City of Plymouth Planning Commission Regular Meeting Agenda Wednesday, February 8, 2023 – 7:00 p.m. City Hall & Online Zoom Webinar

RE: : 980 West Ann Arbor Trail – Site Plan Approval Review for Soothing Dental PLLC

Please find below our responses (in **bold**) to the comments received from the Plan Review Letters provided by Carlisle Wortman and Wade Trim dated January 5th and 3rd respectively.

**Site Plan Review
For
Plymouth, Michigan**

SHEET TITLE:
LANDSCAPE PLAN
 SHEET NUMBER:
L1.0

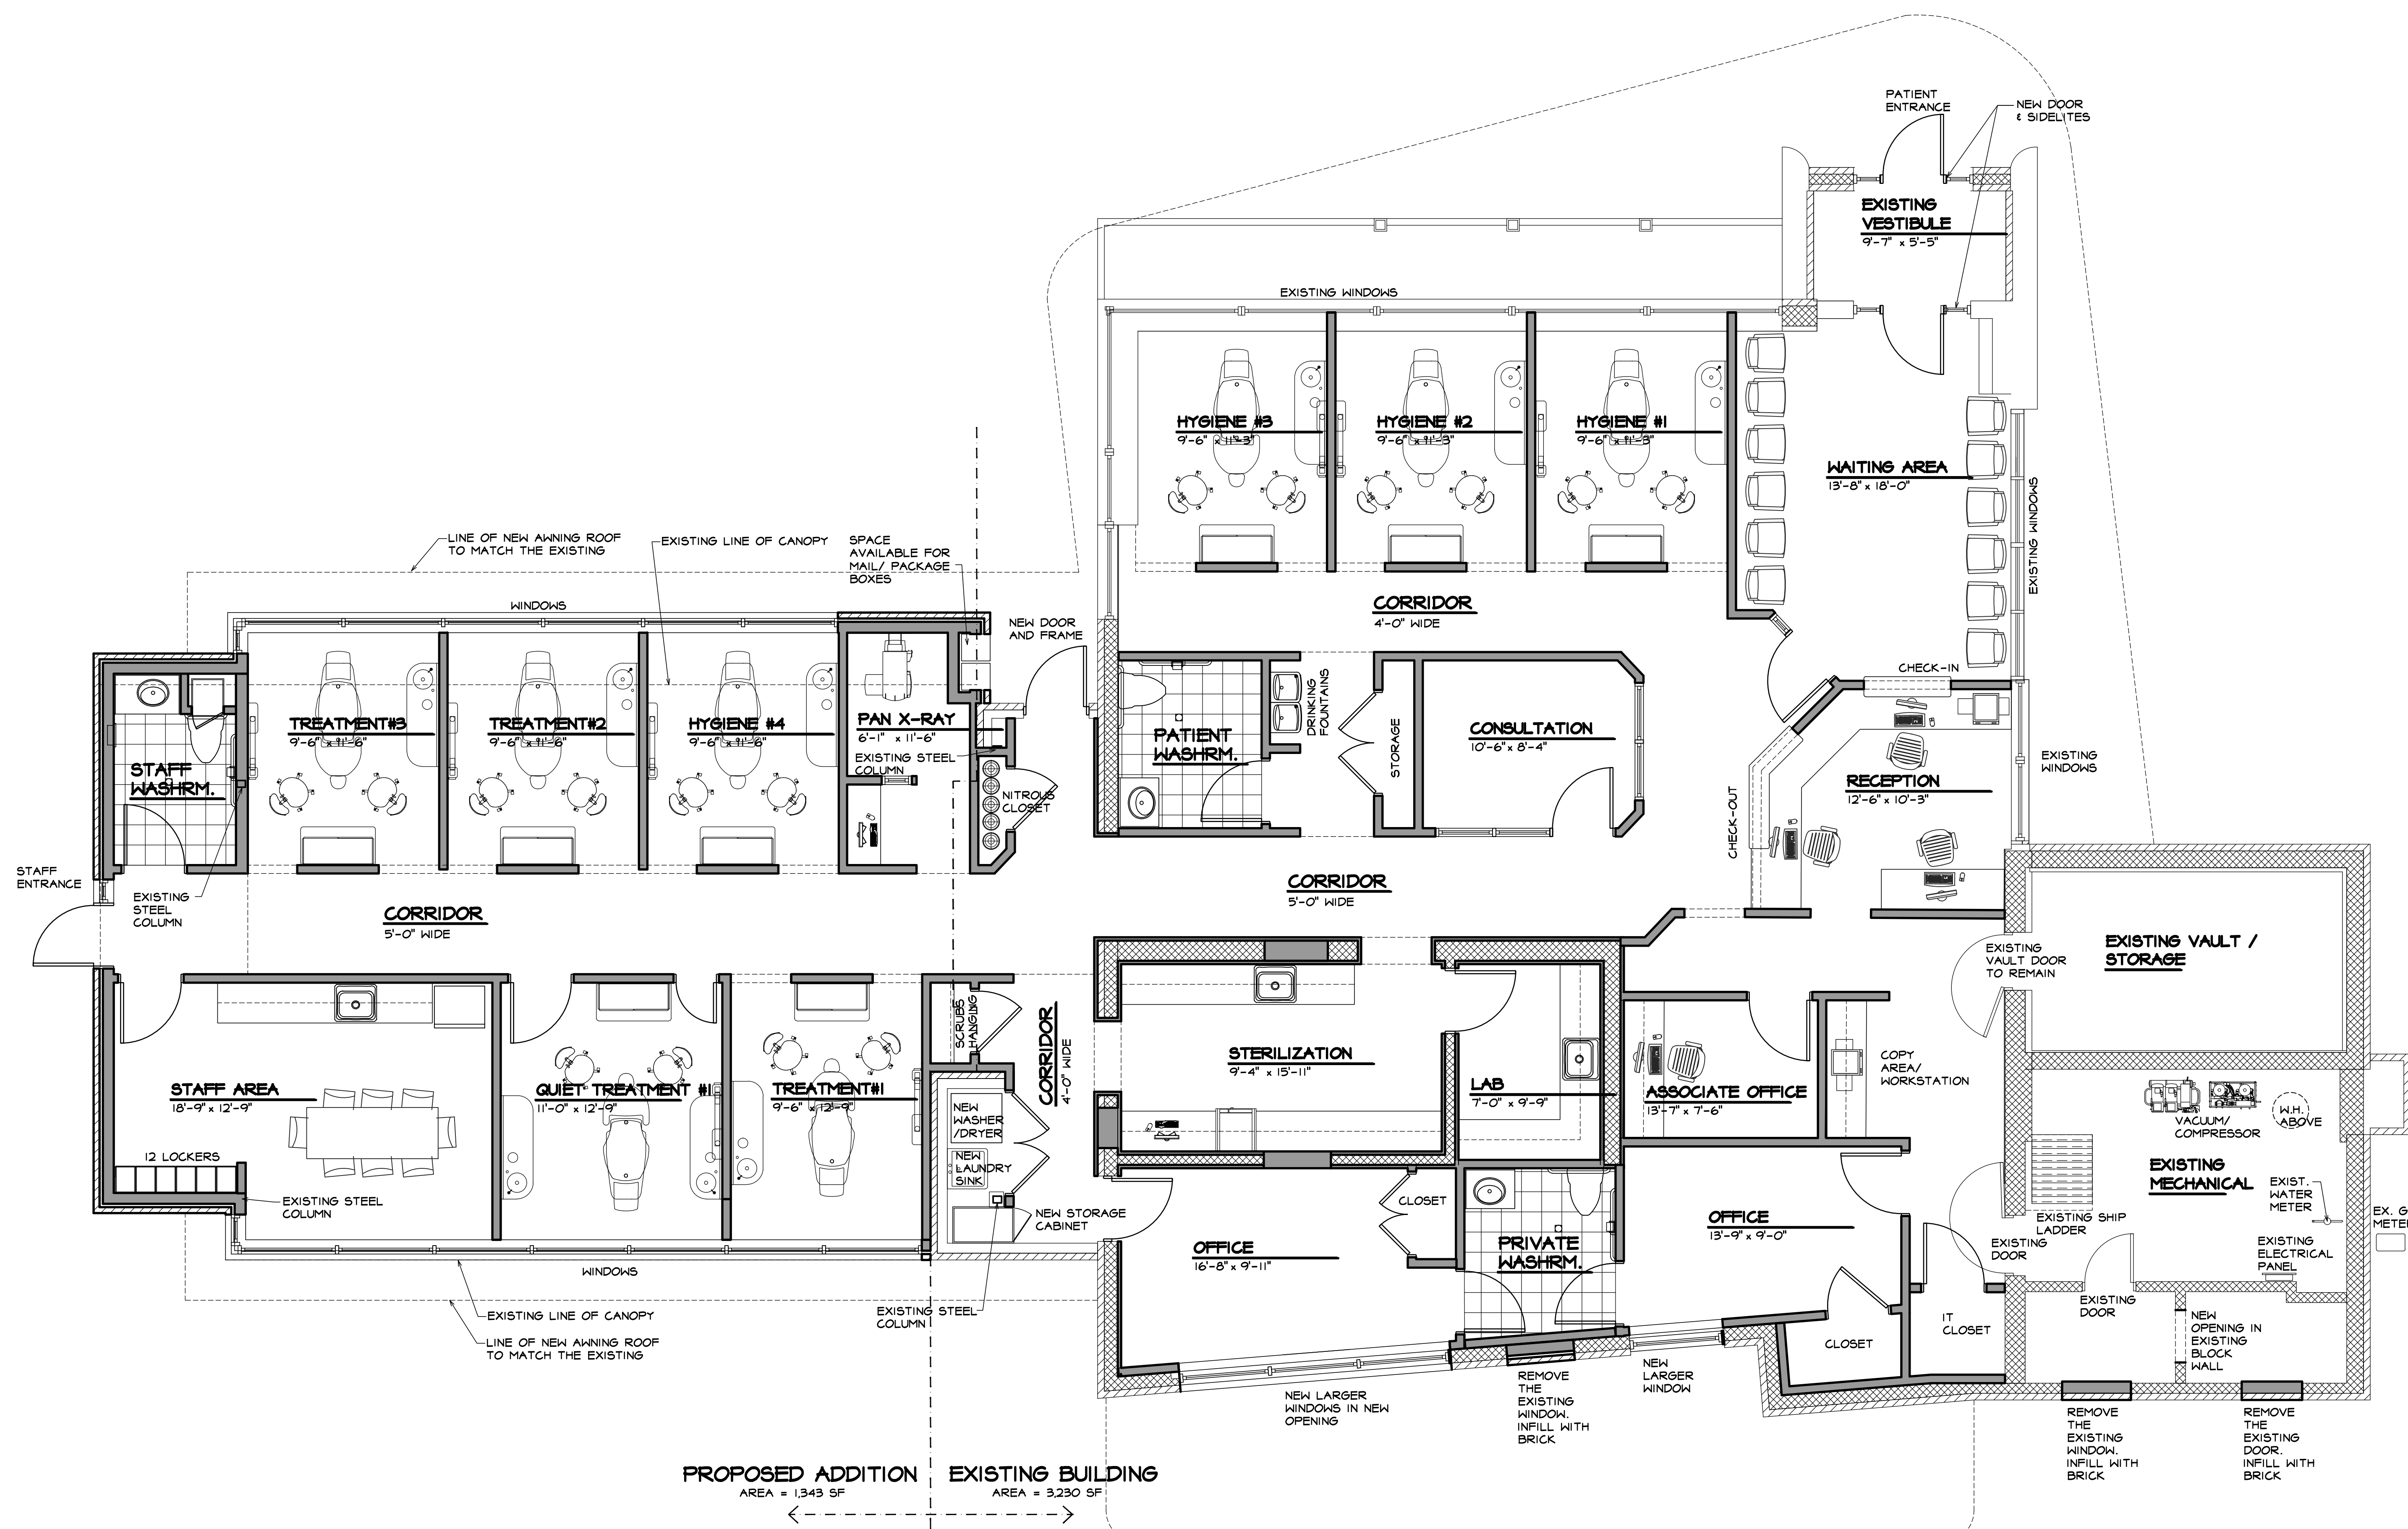
1. Provide landscape plan illustrating compliance with Sec. 78-165, 78-166, 78-167, 78-168, and 78-171.
A landscape plan has been added to the plan set.
